MEMORANDUM FOR: Victor Stello, Jr., Director, TMI Operations
FROM: Don Davis, Duty Officer Shift B
SUBJECT: RESPONSE TO REQUEST FOR HEADQUARTERS ADVICE
ON COOLDOWN

ADVISORY REPORT

REACTOR SYSTEM COOLDOWN

TMI-2

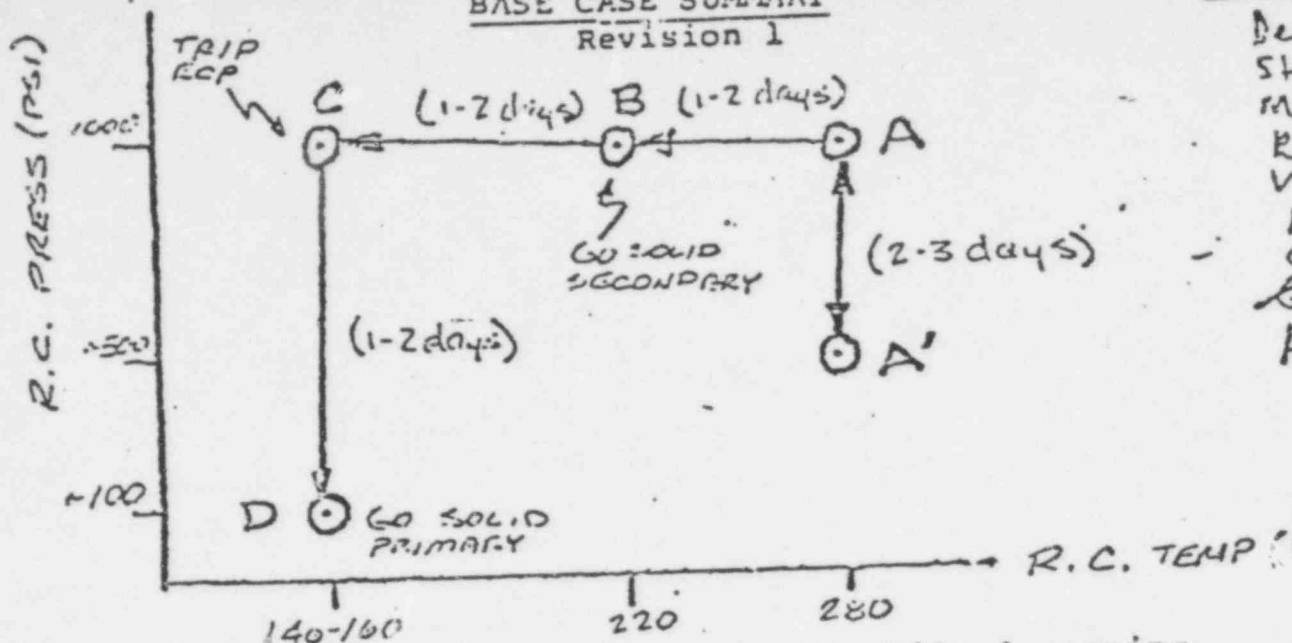
The purpose of this report is to summarize the recommendations of the HQ Technical Support Teams with respect to the cooldown of the reactor system. In particular, that phase of cooling down the reactor system from a temperature condition of about 280°F, to a temperature of 150°F at a coolant pressure of about 1000 psi (see attached figure).

MINIMUM ALLOWABLE CONTAINMENT PRESSURE VS. TEMPERATURE
DESIGN EXTERNAL PRESSURE = -2.5 PSIG

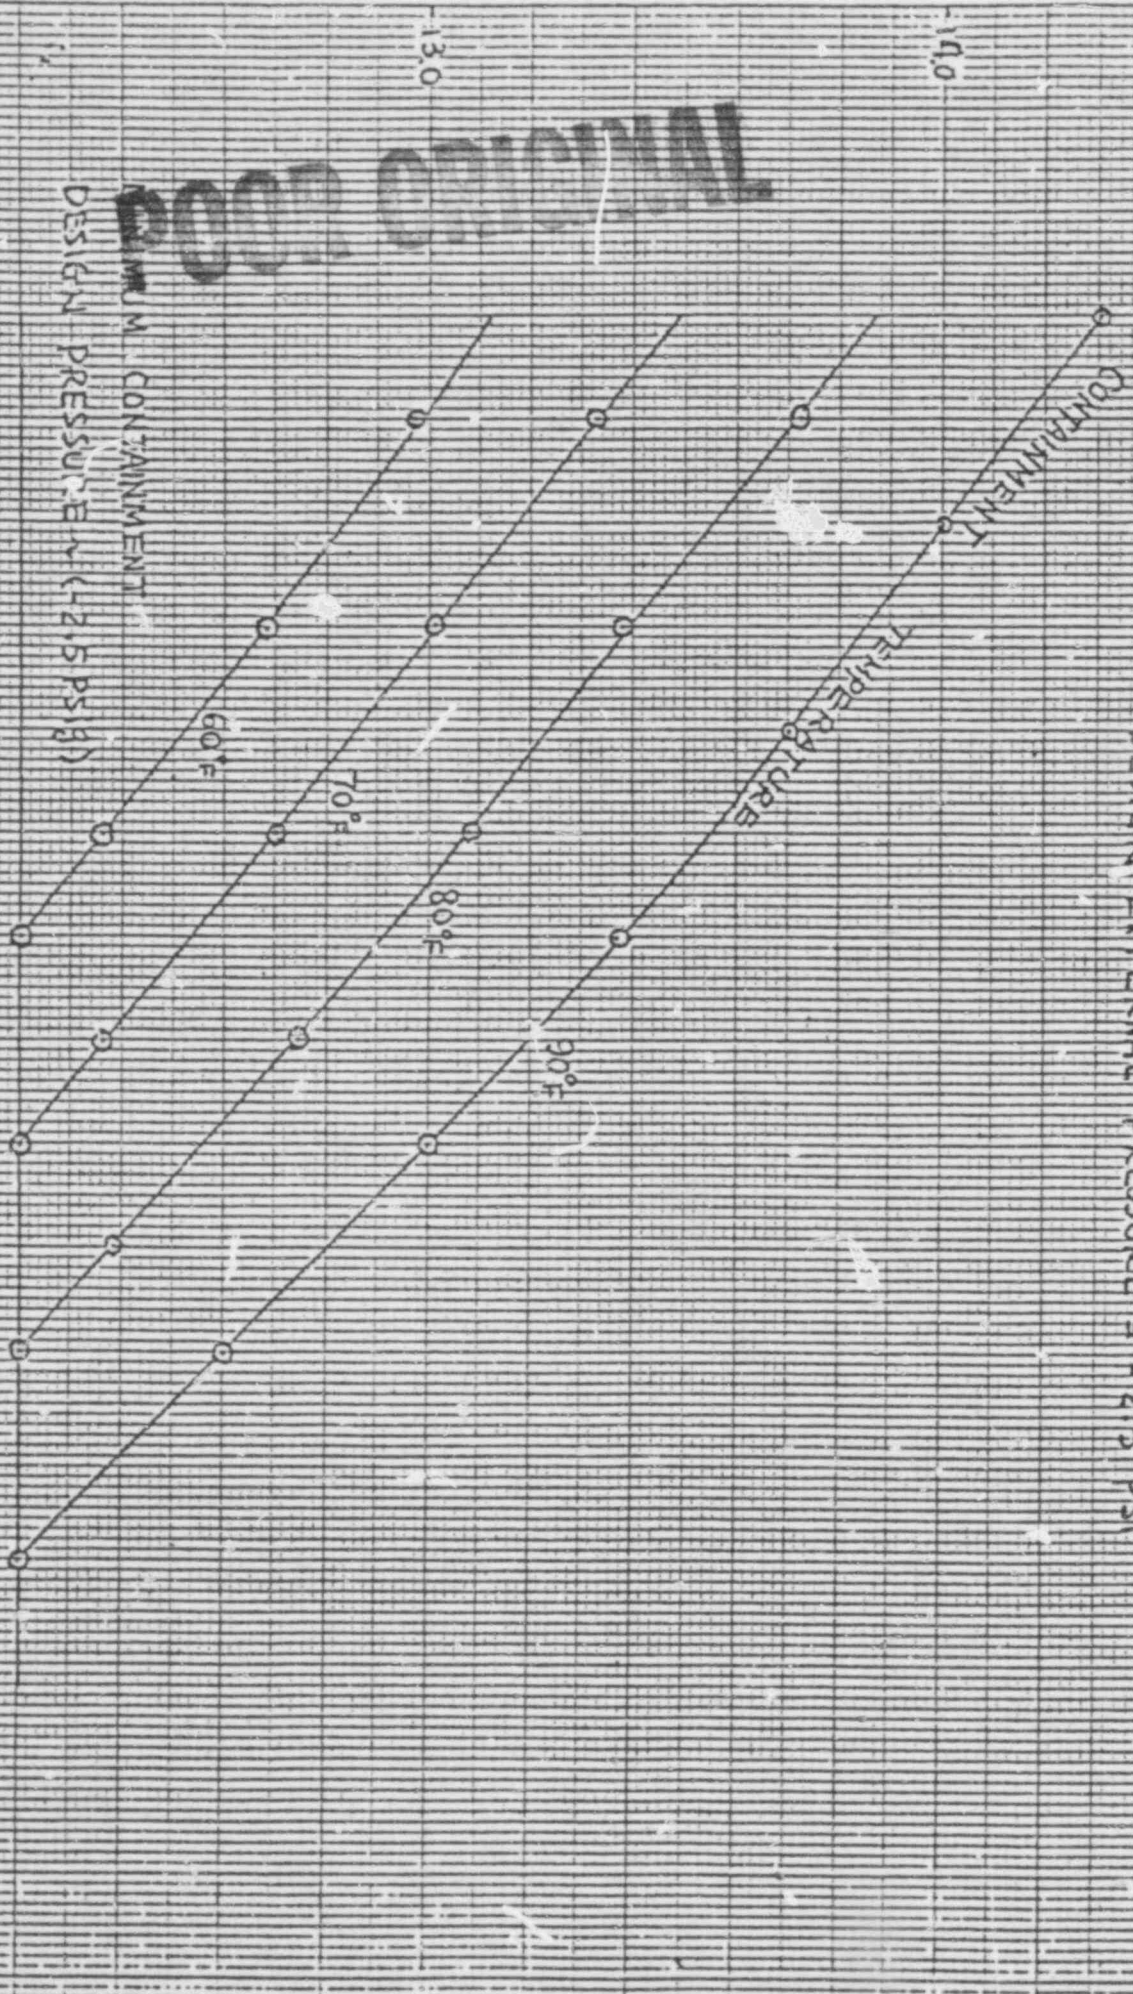
The containment internal pressure has been slightly lower than ambient pressure for most of the time since the accident. At the present time, the containment is at approximately a 0.9 psi reverse pressure differential. Since the design pressure is 2.5 psi, the current pressure is not of immediate concern. Current operating procedures indicate that the water flow to the fan coolers should be terminated if the reverse pressure differential reaches 2.0 psi. This action would effectively terminate further cooldown of the containment atmosphere thereby terminating the transient. In any case, this would be a rather slow transient allowing sufficient time for proper action. We believe, however, a more severe transient should also be considered. This transient is the inadvertent operation of the containment sprays. Initiation of the sprays would result in rapid cooling of the containment atmosphere causing a corresponding rapid decrease in containment pressure. The magnitude of the pressure decrease will depend upon the inlet spray water temperature (BWS water temperature). To assure that the containment does not exceed the design reverse differential pressure of 2.5 psi, the containment parameters should be maintained above minimum values as shown in the enclosed figure. The figure indicates that for a given inlet spray water temperature, the containment temperature as well as containment pressure should be maintained above minimum values. The pressure could be controlled by the addition of a noncondensable gas such as nitrogen or dry air. This procedure has apparently been followed previously to decrease the reverse differential pressure to below 1 psi. Control of containment

temperature could also be achieved by terminating the water to the fan coolers. Since the fan operation would continue, proper mixing of the atmosphere would be maintained while eliminating the heat removal mechanism. Since the consequences of exceeding the reverse design pressure differential is unknown, we believe it prudent to maintain containment conditions as indicated above to allow for inadvertent spray operation
